STAFF RECOMMENDATION
613 17th Avenue North (MLK, Jr Academic Magnet School)
April 20, 2016

Application: New construction-addition
Map and Parcel Number: 09208001600
Council District: 19
Applicant: JC Elder, Bauer Askew Architecture
Project Lead: Robin Zeigler, robin.zeigler@nashville.gov, 615-862-7970

<p>Description of Project: The applicant proposes an addition (phase I.b.) to an addition approved in 2015.</p> <p>Recommendation Summary: Staff recommends approval with the conditions that staff provide final approval of masonry design, dimensions and color and metal colors and final approval of windows and doors. With these conditions, the project meets the design guidelines for new construction on a Landmark site.</p>	<p>Attachments A: Site Plan B: Elevations</p>
--	--

BUILDING ELEVATIONS

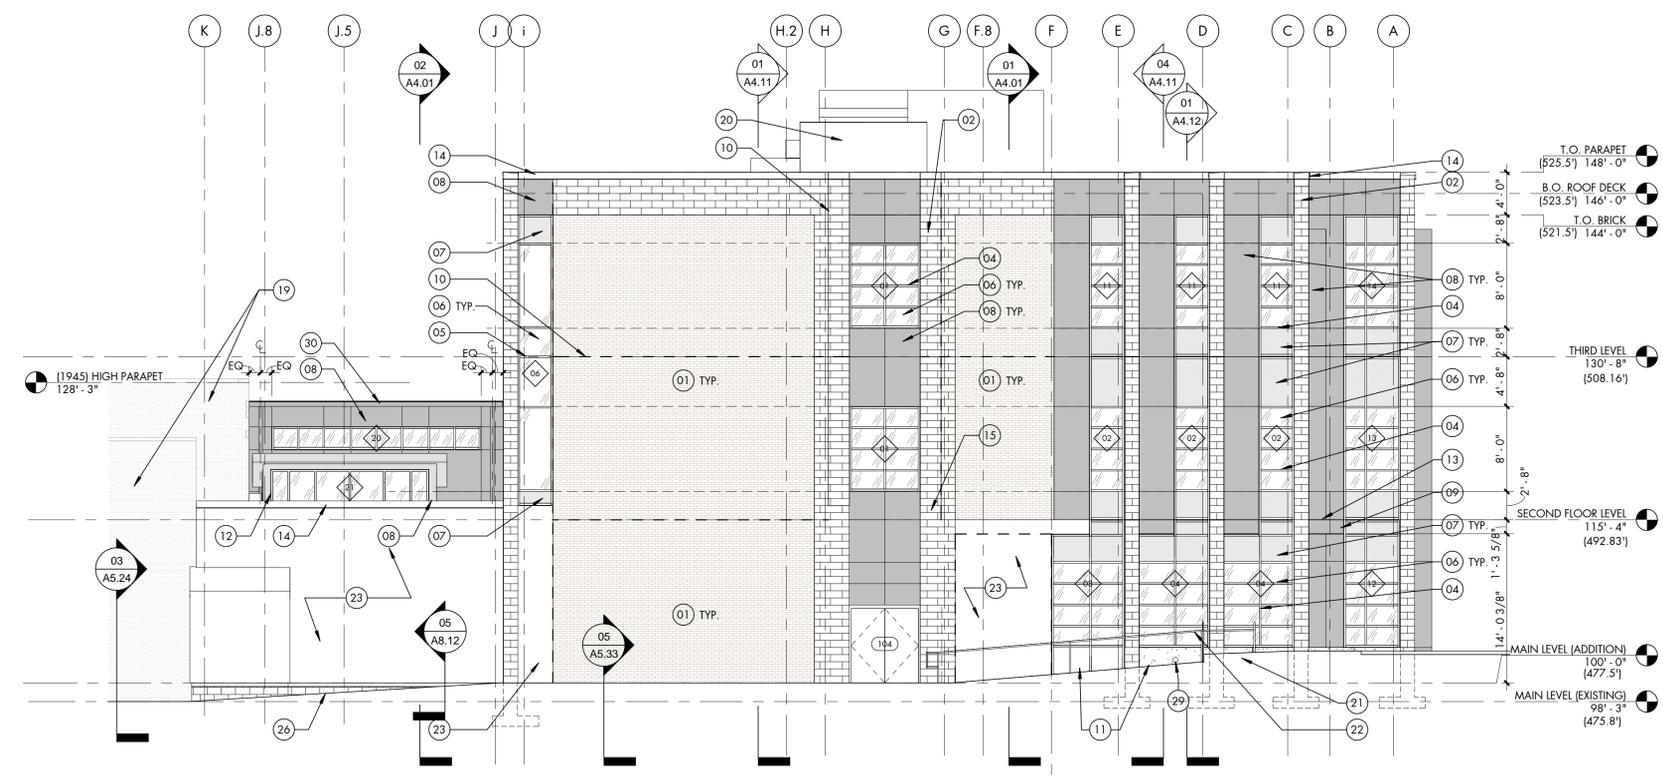
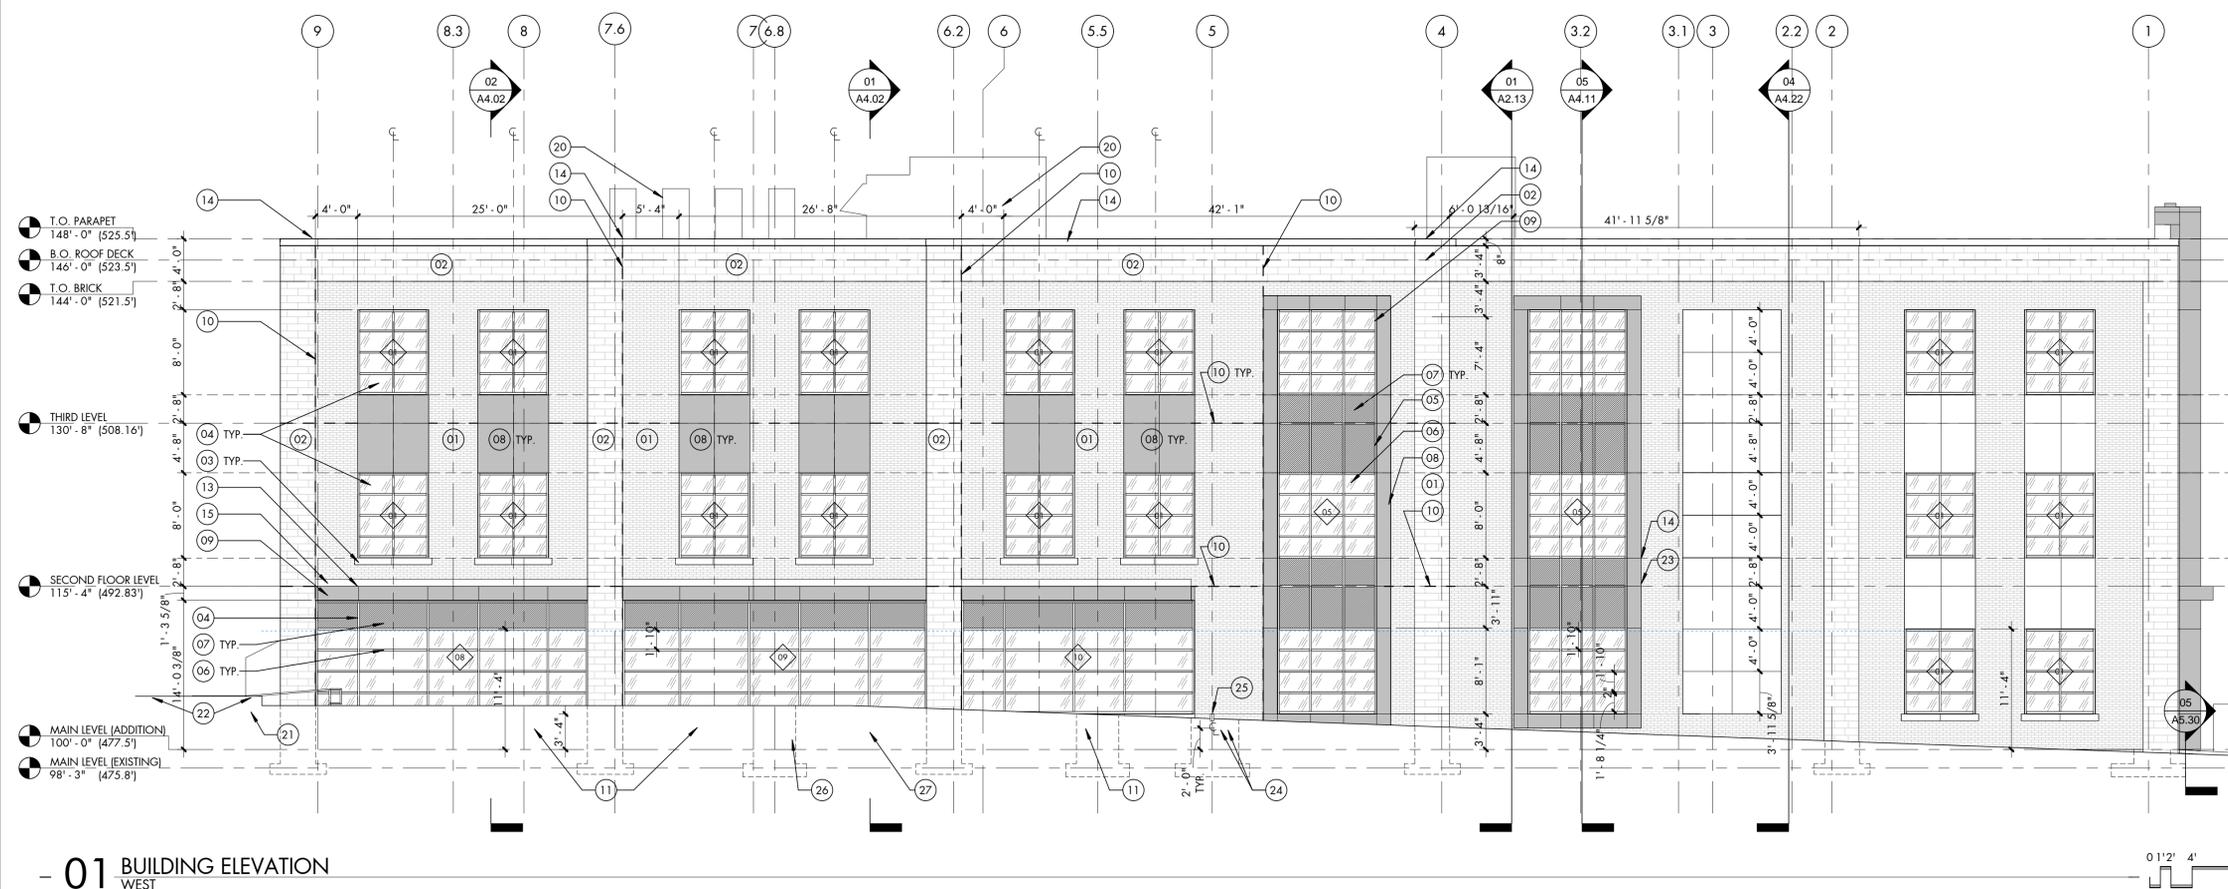
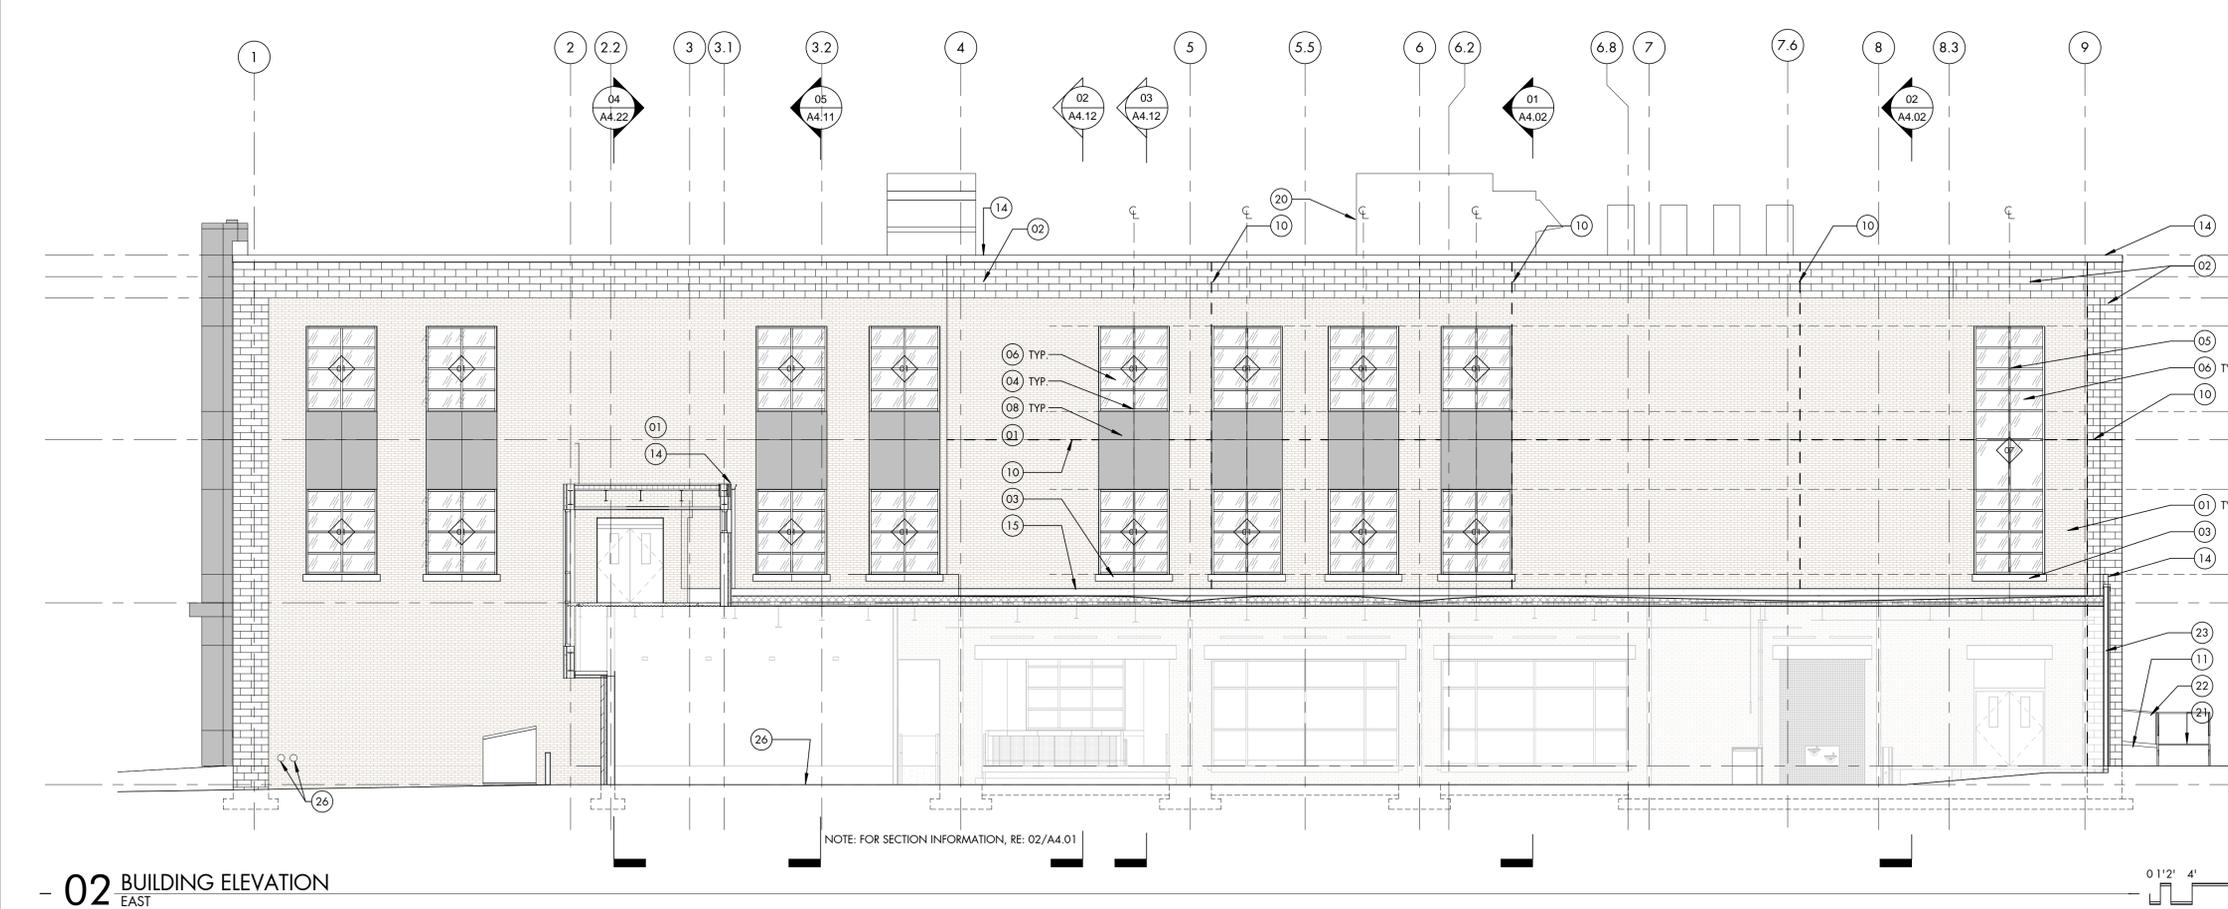
Compatibility of Massing & Form: The addition will be three-stories with a flat roof and parapet, similar to the historic portions of the campus. The façade is broken into four bays, with a taller central bay, again, similar to the historic portions of the campus. A two story portion attaches the new building to the two-story existing building, creating a visual break between the historic addition and the taller new construction. The façade facing Dr. DB Todd Blvd will not affect the historic character of the campus as it will not be seen in relationship to the original building nor will it physically touch the earliest building on campus. The Jo Johnston Ave façade will have an impact on the historic portion of the campus due to its proximity to the 1945 addition; however, this is minimized with the lower-scale two-story connector piece. The project meets section II.4 of the design guidelines.

Compatibility of Materials: Materials for the siding include brick, calcium silicate masonry units, architectural exposed concrete and metal panels. The masonry products are similar to the materials used on the historic building and provide for a modern interpretation the simple brick and stone. Staff recommends final review of the masonry and the metal panel colors. Windows and their components include aluminum storefronts, metal panel rain screens, spandrel glass at the floor lines, and painted aluminum curtain wall. Staff recommends final review of masonry design, dimensions and color, metal colors and window designs.

Staff recommends approval with the conditions that staff provide final approval of masonry design, dimensions and color and metal colors and final approval of windows and doors. With these conditions, the project meets the design guidelines for new construction on a Landmark site.
